Product Change Notification

PCN Number:	RLPCN263901
Product Category:	Electro-Mechanical Automotive relay
Subject:	Bobbin/Base fixing method change
Product series:	FTR-P3 series
Date:	21 September, 2026

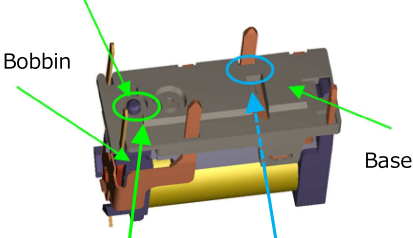
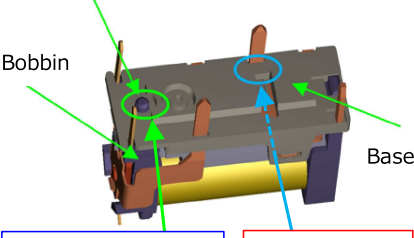
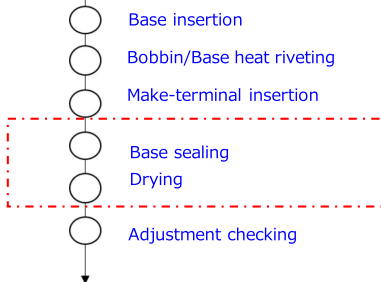
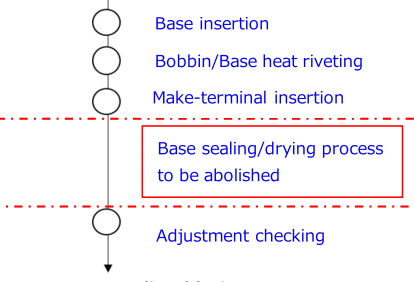
Bobbin/Base fixing method is going to be changed into only heat riveting. Hence, Base sealing/drying process is going to be abolished. And Base shape changes are also going to be implemented.

Current	After changed
Change detail	Fixing Bobbin and Base with adhesive after heat riveting  Bobbin Base  Bobbin/Base heat riveting point Make-terminal insertion point	Fixing Bobbin and Base by heat riveting only  Bobbin Base Adding the step in Bobbin/Base heat riveting point for close contact Adding Press-fit shape in Make-terminal insertion point  Bobbin/Base heat riveting point Make-terminal insertion point
Manufacturing process	 Base insertion Bobbin/Base heat riveting Make-terminal insertion Base sealing Drying Adjustment checking Base sealing/drying process included	 Base insertion Bobbin/Base heat riveting Make-terminal insertion Base sealing/drying process to be abolished Adjustment checking Base sealing/drying process to be abolished

- Bobbin/Base fixing method is going to be changed into only heat riveting.
- Base sealing/drying process is going to be abolished.
- This change enables to eliminate adhesion of sealing material inside aluminum magazine being used in Base sealing/drying process and the possibility of secondary accident (abrasion of resin material, sealing material coming off) due to that.
- Base shape change is also going to be implemented for purpose of improving close contact on heat riveting, countermeasure for abrasion of resin material.
